Technical Comments on the
Environmental Protection Agency (EPA) Revised Cross-State Air Pollution Rule Update
for the 2008 Ozone NAAQS

Prepared for the

Midwest Ozone Group

December 13, 2020

Figure 1. Coal Rank: 12-State versus 22 States in Initial CSPAR Region

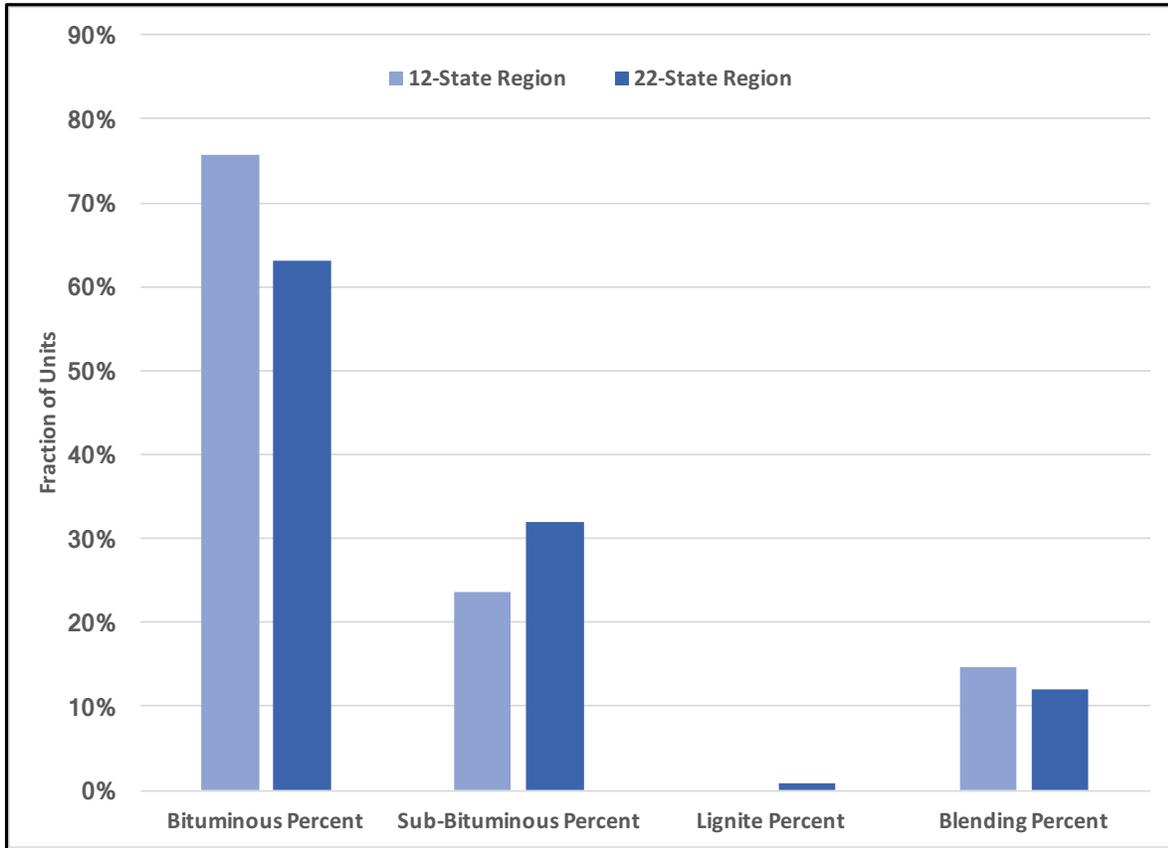
Most notable is the significantly higher percentage of boilers firing bituminous coal operating in the 12-state region targeted by EPA in its proposed rule. Bituminous coals generally contain higher sulfur which increases the concentration of sulfur trioxide (SO₃) in the gas stream, affecting catalyst formulation, minimum achievable generating load, and formation of deposits that accumulate on downstream air heater surfaces. Figure 1 shows approximately 77% of units in the 12-state region fire bituminous coal compared to 62% of units in the 22-state region. Conversely, 22% of the units in the 12-state region fire subbituminous coal compared to 32% in the 22-state region.

Figure 2. Coal Sulfur Content: 12-States vs. 22 States in Initial CSAPR Region

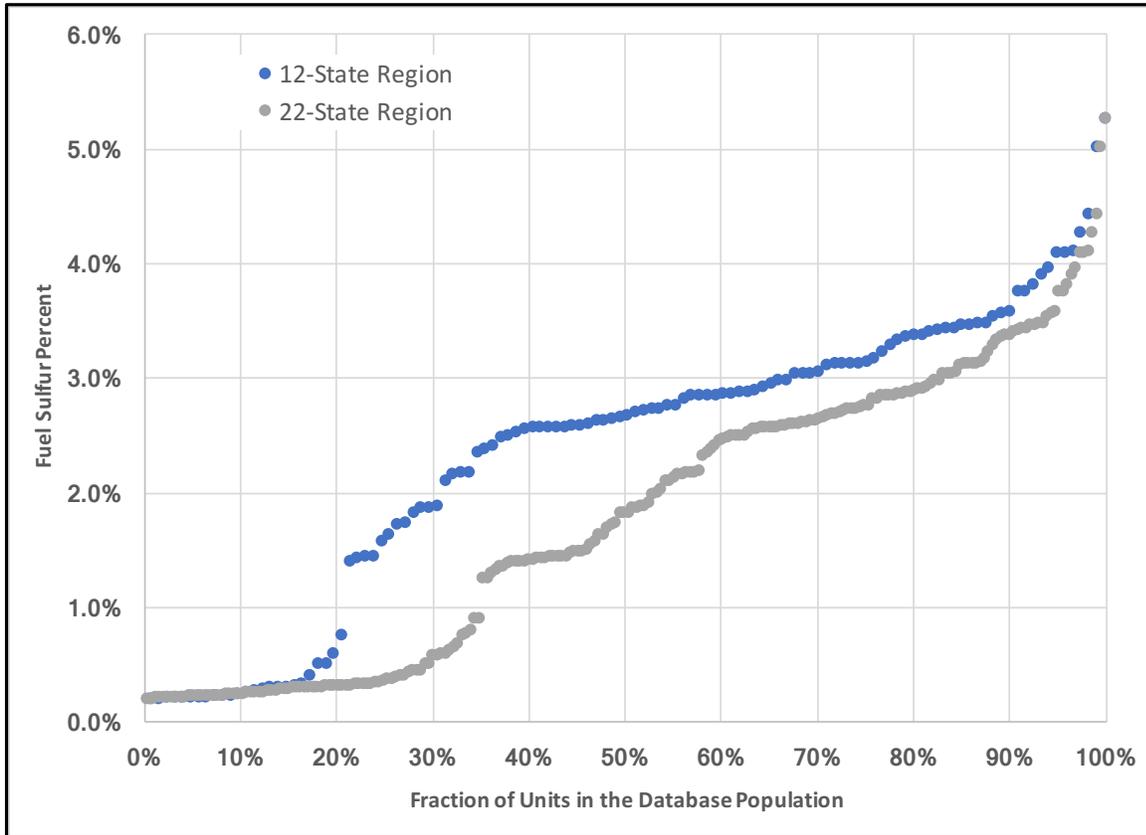
More striking than the inventory of units firing bituminous coal is the average sulfur content of the coal. Figure 2 presents the distribution of coal sulfur content over the unit population. Notably, the average sulfur content of units in the 12-state region is 2.4% in contrast to the average of 1.8% in the 22-state region. This difference in sulfur content will affect SCR design and operation.

As an example, sulfur content of 2.4% implies flue gas SO_3 content of 40 ppm, whereas for a coal with sulfur content of 1.1% an SO_3 content of 20 ppm is observed.⁴ Higher SO_3 will affect SCR performance and operating cost – the specification of SCR catalyst will likely require lower SO_2 oxidation rates which also can lower activity for NO_x removal. As a result, greater catalyst volume is required with higher catalyst management costs. Perhaps more important, the SO_3 content in the flue gas can establish the minimum load at which the unit can operate without catalyst degradation.⁵ The consequence of higher sulfur coal-fired units in the inventory is the potential for a greater fraction to be required to bypass the SCR at low load, surrendering a portion of the NO_x control capability. There are mitigating actions for this latter impact, but their effectiveness can be uncertain and each imposes additional capital and/or operating cost.^{6,7}

Figure 3. EPA-Inferred Boiler NOx Emission Rates: Bituminous and Subbituminous Coals

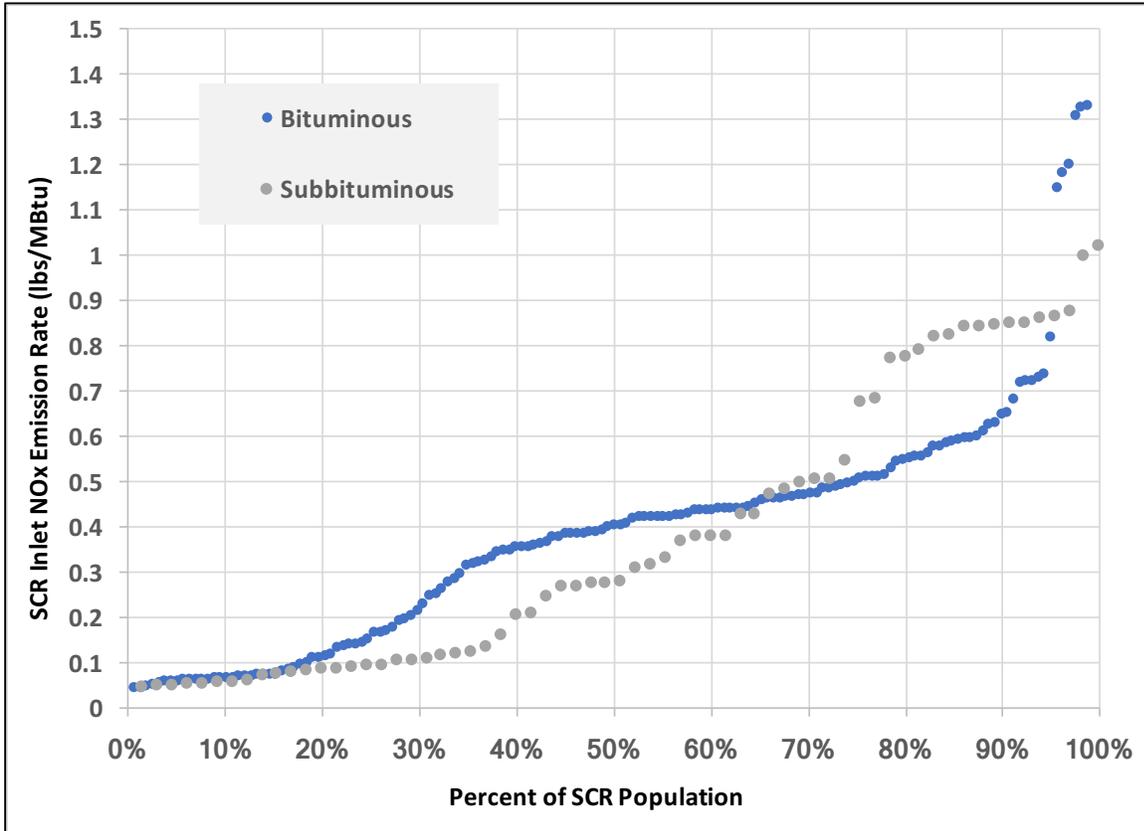
Figure 3 summarizes the boiler exit NOx rates for units in the 122-state region, presented as a cumulative frequency distribution for bituminous and subbituminous coals. Figure 3 shows a notable fraction of units with boiler exit NOx rates below 0.20 lbs/MBtu - for 20% of subbituminous units and 17% of the bituminous units. EPA includes in the analysis only units for which the inferred pre-SCR NOx rate is 0.20 lbs/MBtu or higher.⁸ EPA's inferred boiler NOx rate is too low for many units.

Figure 4. Boiler Exit NOx Emissions: EPA-Inferred vs. “Adjusted” per Industry Input

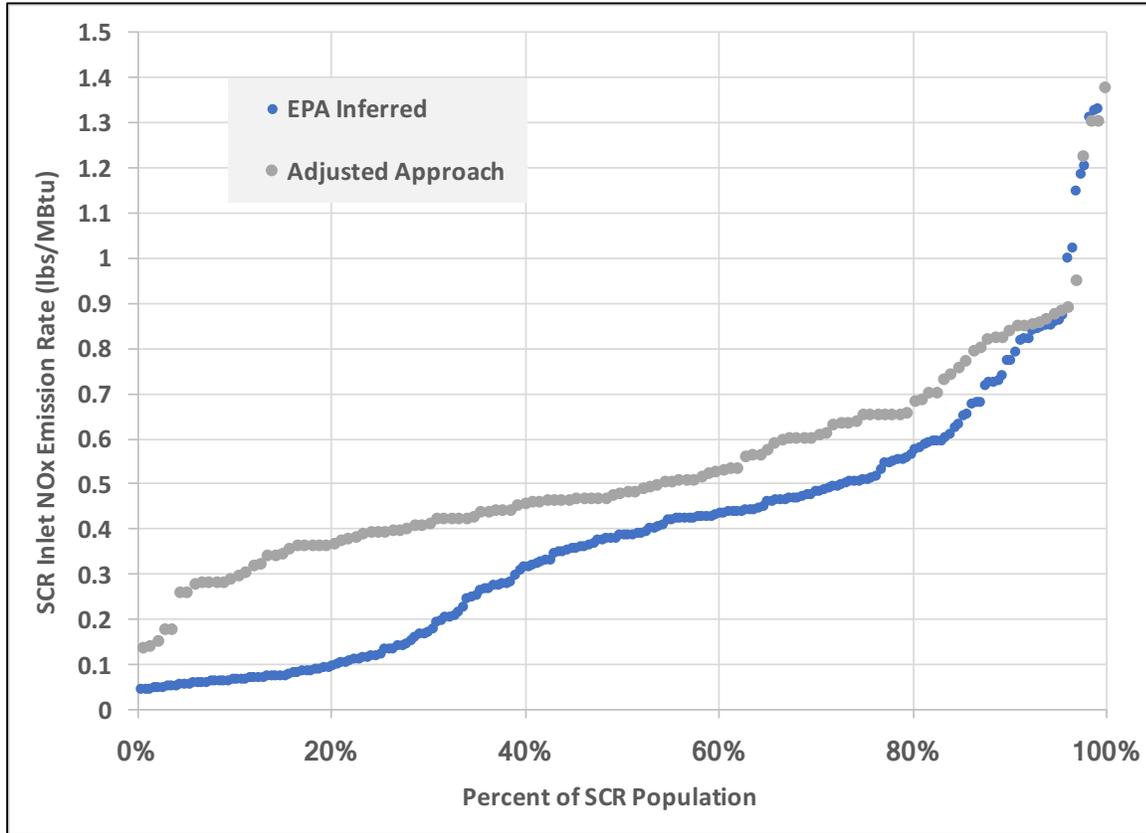
Figure 4 set forth below, presents revised boiler exit NOx rates for the 123 generating units in the 12-state region compared to the 223 units in the 22-state region. The “adjusted” approach for this alternative evaluation generates boiler exit NOx rates that are consistent with broad observations, as a consequence slightly elevating the cost to achieve the post SCR controlled NOx emission rate.

Figure 5. SCR Process Reactor Potential to Maintain 90% vs. 80% NOx Removal

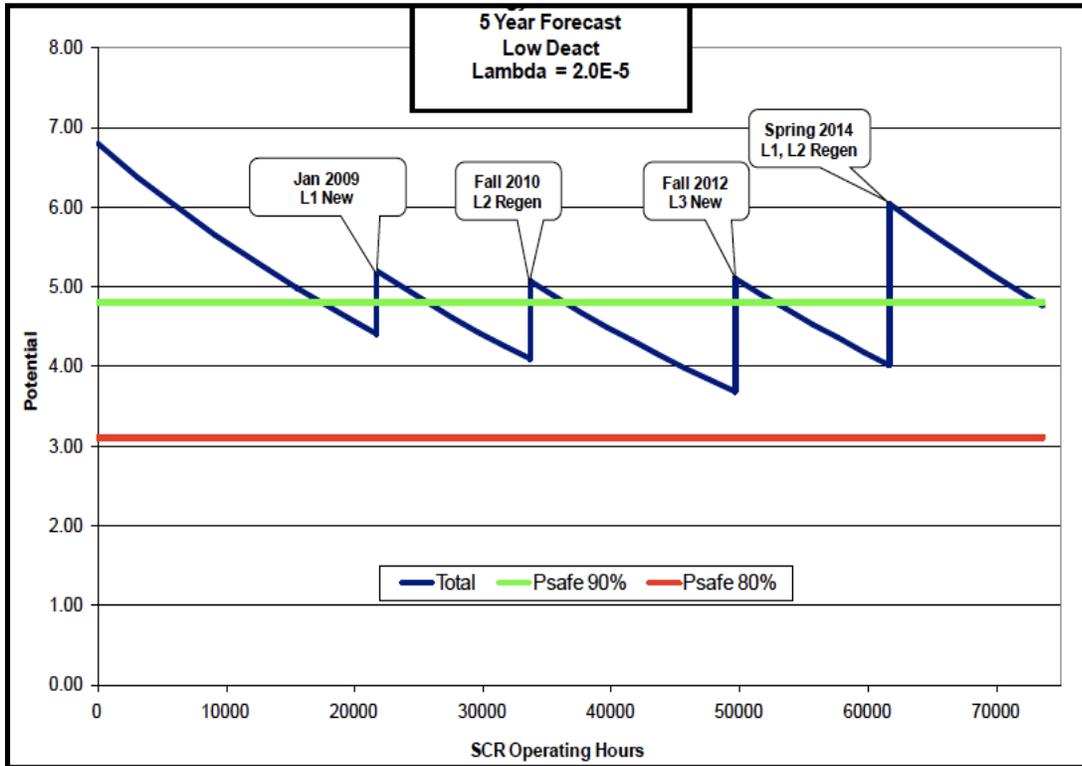
A more authentic estimate of the increase in catalyst volume to achieve 90% NO_x reduction can be derived from catalyst supplier estimates. Figure 5 describes the design from one supplier submitted in a competitive catalyst bid contrasting 80% versus 90% NO_x removal. Figure 5 shows 30% more reactor “potential” is required to achieve a 90% design; which for the same catalyst composition and geometry this implies a 30% increase in catalyst volume.

For this evaluation, the IPM-derived relationship describing variable operating cost is revised to reflect the non-linear increase in catalyst volume to achieve 90% NOx reduction. As derived from the relationships developed for the IPM, the catalyst variable O&M to achieve 90% NOx removal increases by 8.7% from the value required for 80% NOx removal.¹³ The data in Figure 5 suggests the increase in catalyst volume to elevate NOx removal from 80% to 90% is at least 30%. The 30% increase is inferred by comparing values of a basic SCR reactor design variable – the Reactor Potential (denoted as “potential” on the left-hand vertical axis). The increase in catalyst volume to elevate a reactor designed for 80% NOx reduction to 90% NOx is reflected by the ratio of “PSafe 90%” to “PSafe80%”. The values of this dimensionless metric are 4.82 for 90% compared to 3.2 for 80% – an increase of 50%. A value of a 30% premium is used for these calculations.¹⁴

Figure 6. Definition of Burner Zone Liberation Rate: Four Major Boiler Suppliers

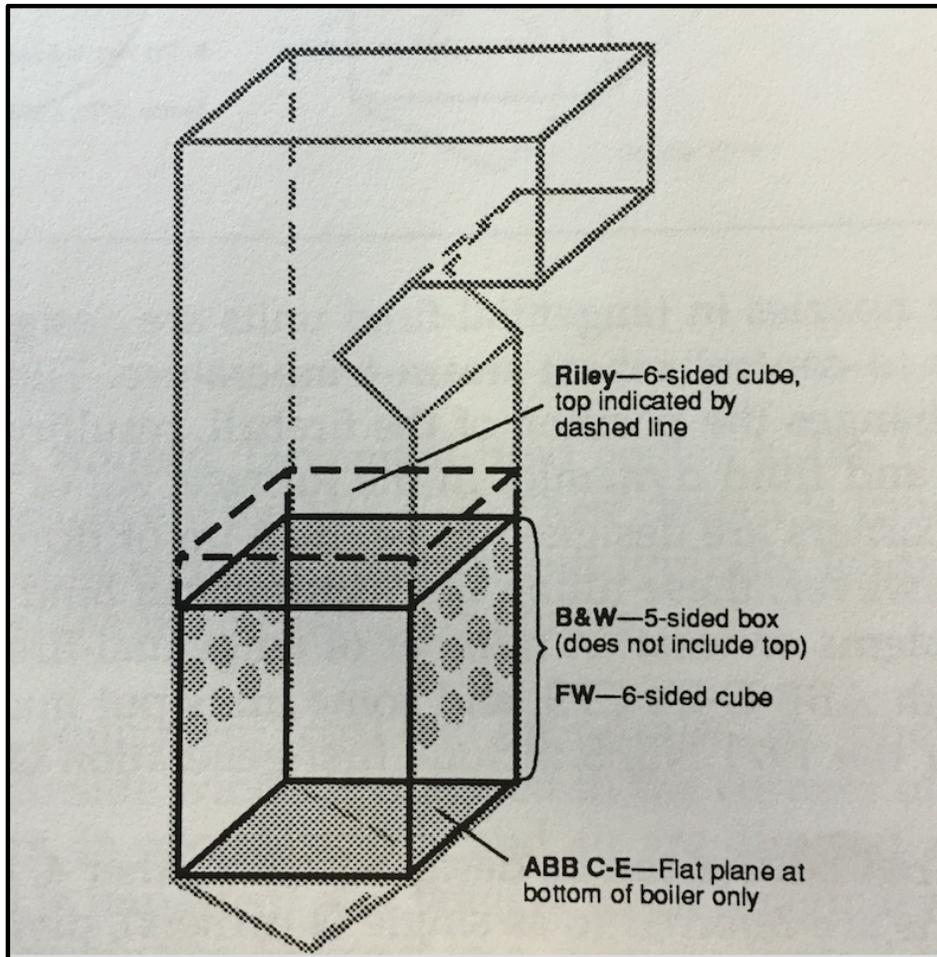
Figure 6 presents a general boiler layout used to define the BZLR for the four major boiler suppliers.²³ Prior to concerns for NO_x reduction, BZLR was selected almost exclusively to maximize fuel utilization (e.g. achieve minimal carbon burnout) and avoid furnace corrosion while minimizing boiler footprint – a key factor that determines capital cost. NO_x control mandates changed boiler design criteria – BZLR was specified to support controlling NO_x emissions.²⁴ This change in BZLR was prompted by the need to lower flame temperature to minimize thermal NO_x and provide space for the extended length, low NO_x burners. The most recent boiler designs employ relatively low BZLR to achieve these NO_x rates.

Figure 8. Example Timelines for Engineering and Installation of SCR Process Equipment

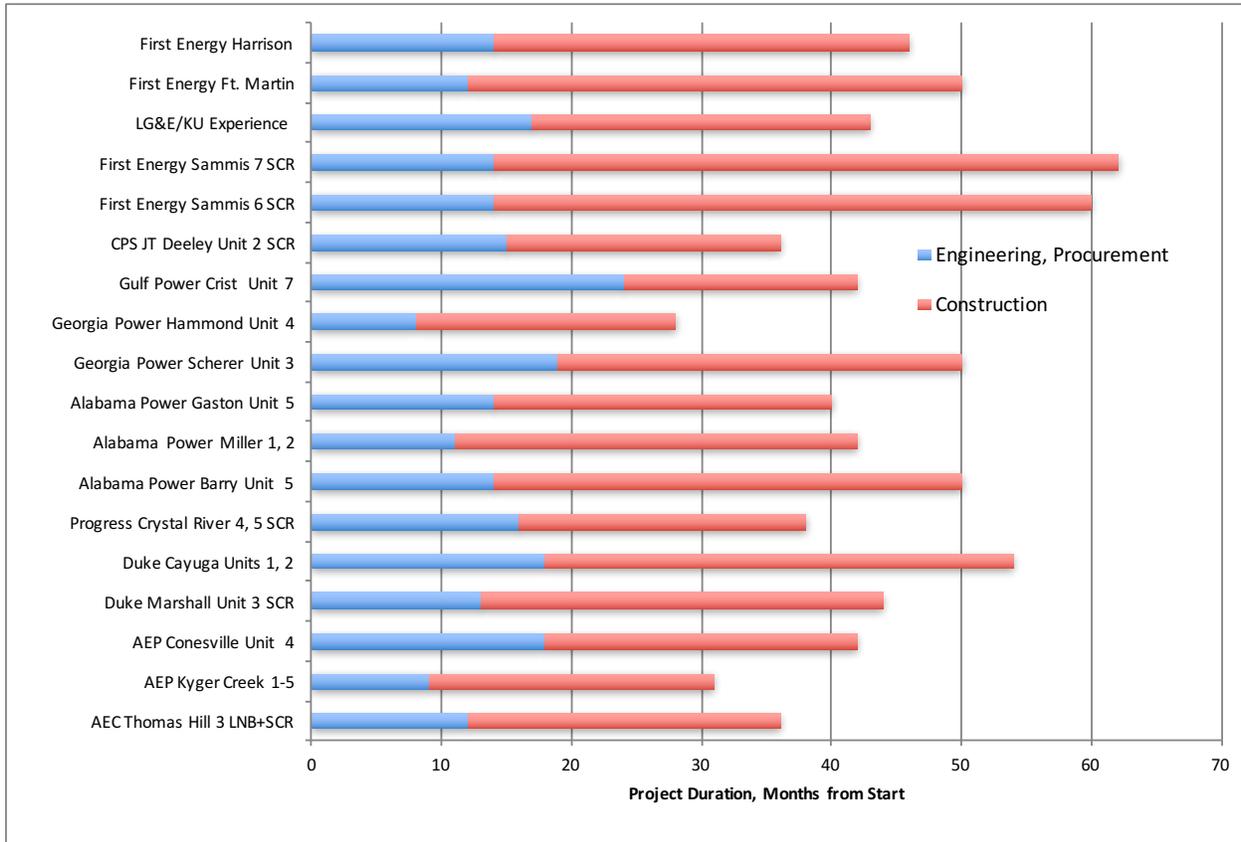
Utility industry experience with SCR process design and procurement supports a minimum of 39 months for most SCR projects. Figure 8 presents the schedule for installation of 18 projects from the beginning of engineering through process startup.

All other SCR installations required approximately 39 months or more. In summary, although it is possible select units could retrofit SCR in less than 39 months, such examples appear unique. Either process design was established for a near-identical application, and/or the economies of scale for installing SCR on multiple units could be exploited. Some installations required more than 50 months due to site-specific conditions.

Figure 10. Example Timelines for Engineering and Installation Combustion Controls

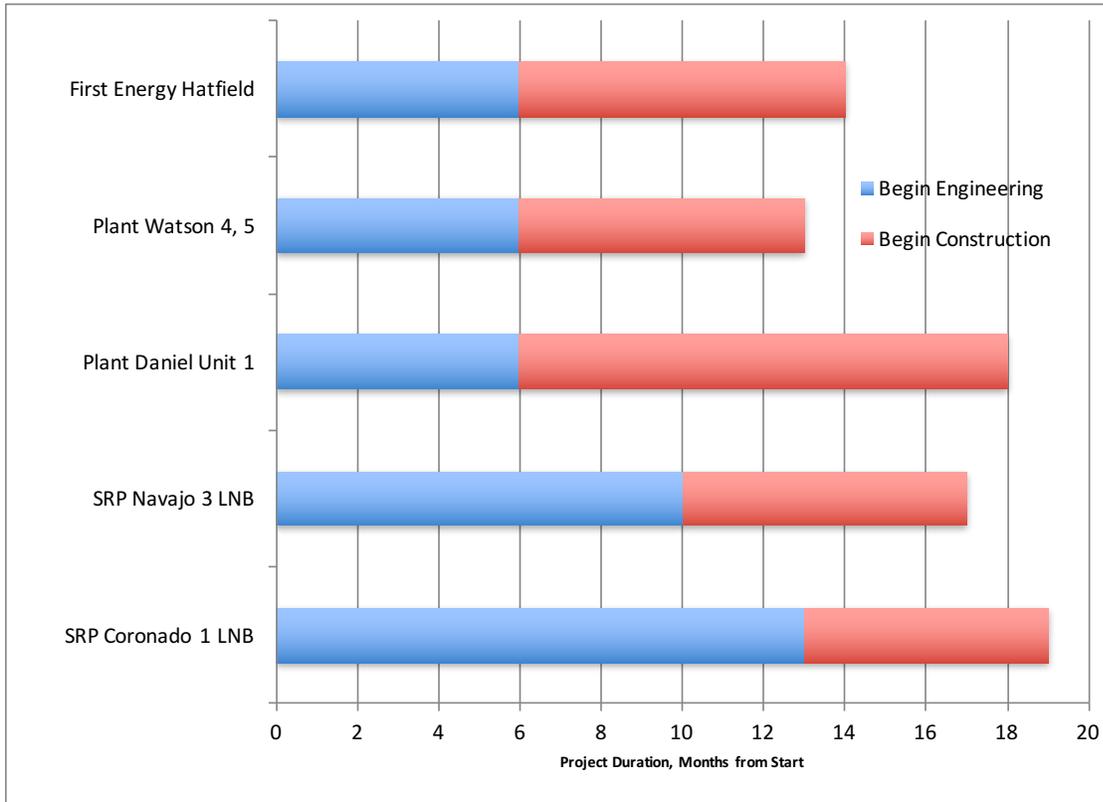
Figure 10 shows a delay to the 2022 state emission budgets for the ozone season is necessary due to the time required for design, procurement, and installation of combustion controls for five example units is at least 13 and up to 19 months. This time frame reflects the entire scope of work which includes: the specification, solicitation and selection of a successful supplier, final design and the procurement, installation, and startup of process equipment. The most abbreviated schedules – for Units 4 and 5 at Plant Watson - is 13 months while Hatfield required slightly more time at 14 months. The other examples indicate from 17 to 19 months a time frame that challenges even the ability to meet the 2022 mandated timeline.

In summary, combustion controls could not be deployed in time for the 2021 ozone season; and only a small fraction could be deployed even for the 2022 season.
